CERTIFICATE OF SURVEY PROPOSED SPLIT

Re: Land Division
Parcel # 15-14-430-008

From: Chris McLeod, AICP, Manager of Planning
 To: Laurie Taylor, Director of Assessing
 Date: 3/13/25
 Re: Land Division Application for 15-14-430-008 (466 Driftwood)

From: Jason Boughton, AC, Engineering Utilities Specialist
To: Laurie Taylor, MMAO (4), Director of Assessing
Date: March 17, 2025
Re: **Land Division Application Parcel Number 15-14-430-008**

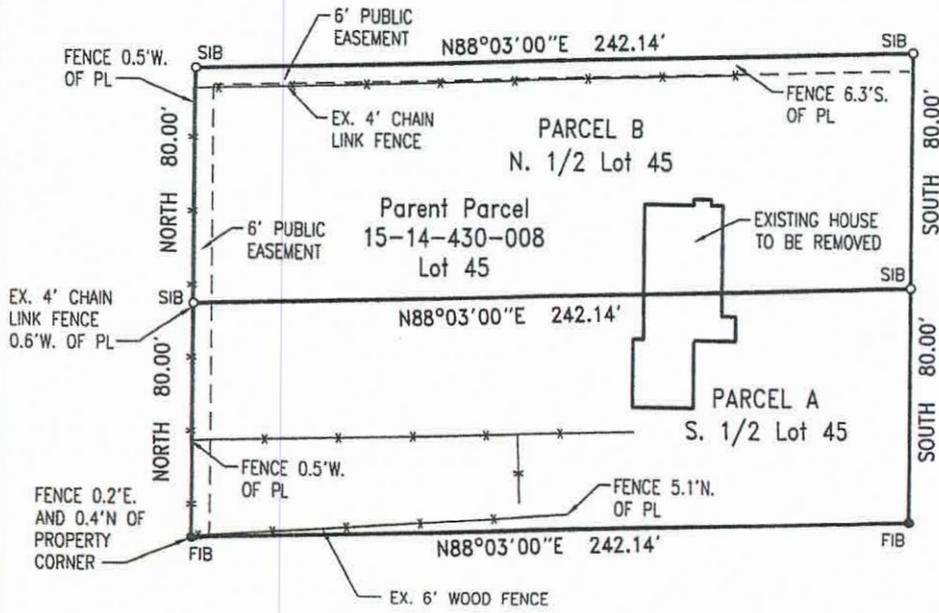
1. Minimum Lot Size and Front Width (Section 122-28(b)(2) and 138-5.100-101). The minimum lot size in area and the minimum front lot line width of any lot, outlot, or other parcel of land shall be in compliance with the applicable requirements of the city zoning ordinance. The application proposes to split the existing 160' wide lot, 466 Driftwood, into two (2), 80' wide lots. The existing parcel is subject to the R-3 One Family Residential zoning district. The existing parcel also currently has a residence located in the middle portion of the parcel. It is noted that this residence would be removed if the application was approved. Parcel A is proposed to have a width of 80 feet at the front lot line along Driftwood, and Parcel B is also proposed to have a lot width of 80 feet. Both lots would have lot areas of approximately 19,371.2 square feet based on simple calculations. No actual parcel areas were provided. The minimum lot width requirement in the R-3 district is 90 feet and the minimum lot area is 12,000 square feet.

Requirement	Existing	Proposed	Proposed	Staff Comments
	70-15-14-430-008	Parcel A	Parcel B	
Min. Lot Width 90 ft.	160 feet along Driftwood	80 feet along Driftwood	80 feet along Driftwood	Proposed Parcels A and B do NOT meet the minimum lot width requirements of the R-3 District.
Min. Lot Area 12,000 sq. ft.	38,742.4 square feet	19,371.2 square feet	19,371.2 square feet

- a. The division or partition will result in lots or parcels of land having a size and shape consistent and harmonious with that of other parcels in the area. The splitting of the parcel will result in two (2) parcels that do **NOT** meet the minimum lot width requirements of the R-3 One Family Residential District. The minimum lot width in the R-3 One Family Residential Zoning District is 90 feet; neither lot meets this minimum requirement.

Proposed parcels A and B will have the minimum lot area (minimum 12, 000 sq. ft.) but will not have sufficient width (minimum 90') for the proposed uses and zoning.

This proposed land division is disapproved due to the proposed parcels not meeting the minimum required lot width of 90 ft.

- 1) There is an existing home to be demolished straddling the proposed property line between proposed parcels A and B. The address for the existing parcel is 466 Driftwood Ave.

- 2) A public water system is currently available to both proposed parcels. There is an 8" ductile iron water main located on the west side of Driftwood Ave. The existing house is connected to water. The stop box for proposed parcel A, per inspection report, is approximately 3' south of the proposed property line.

- 3) A public sanitary sewer system is available to both proposed parcels. An 8" ABS truss sanitary sewer main exists within Driftwood Ave. There is an existing sanitary sewer lead for proposed parcel B. The existing lead will need to be field verified to be in good working order prior to connection. There is not a sanitary sewer lead for proposed parcel A. A City of Rochester Hills right-of-way permit is required prior to tapping the sanitary sewer main.

- 4) A 15" reinforced concrete pipe storm sewer owned and maintained by Oakland County is located on the east side of Driftwood Ave. An open ditch exists on the west side of Driftwood Ave. The on-site drainage must be addressed by the Building Department during the building permit review.

- 7) There are power lines along the north and east property lines. Please check for an easement and depict on the survey if one exists or notate that there is not one.

Based on our review and the above comments, the Department of Public Services **objects** to approval of this Land Division. In order for this land division to be approved the following is required: verify if a utility easement exists for the power lines and submit a revised survey.
